Product Change Notification

110881 - 01

Change Notification #: 110881 - 01
Change Title: Intel® Desktop Board DP67BG, Boxed and Bulk
PCN 110881-01, Product Material
Resume TI 1394 controller IC, CPU socket cover change and load plate material change
Reason for Revision: Add CPU Socket Cover change and revised milestone
Date of Publication: September 22, 2011

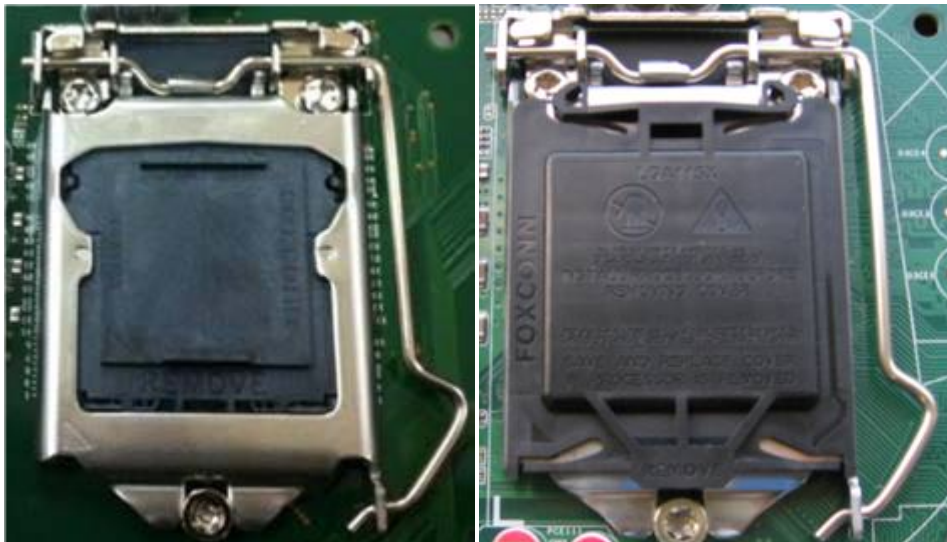
1. The DP67BGB3 product will be resuming the use of the TI 1394 controller IC from the alternate supply (as indicated in PCN 110643) now that global limitations of the silicon have been resolved.
2. The CPU socket cover will be changed to the ILM version as below:

Current load plate

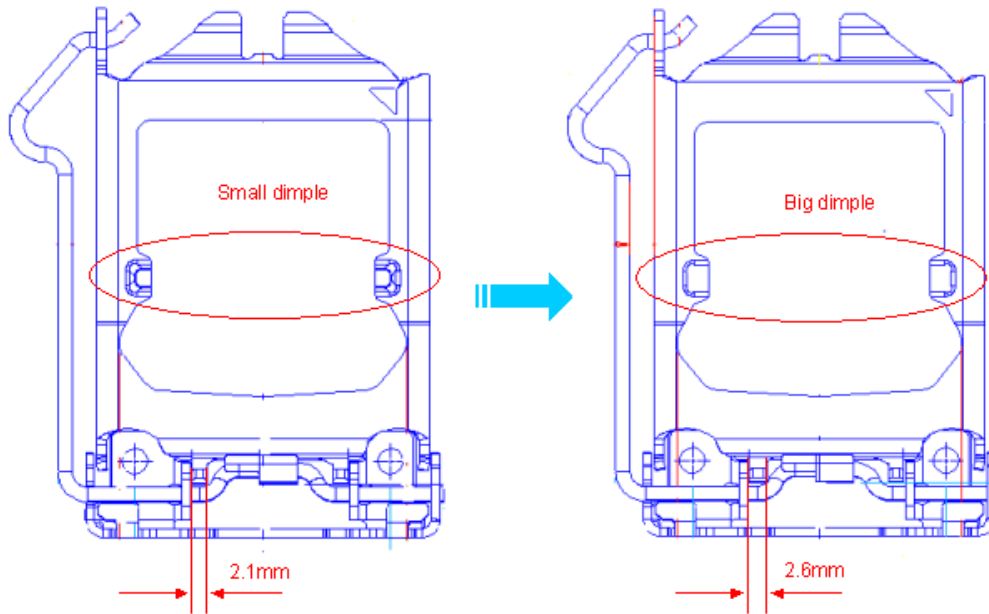
3. The CPU socket ILM load plate material change to anti-corrosion treatment, dimple size change & LP right alignment feature width change to improve testing CPU life span. Change as below:
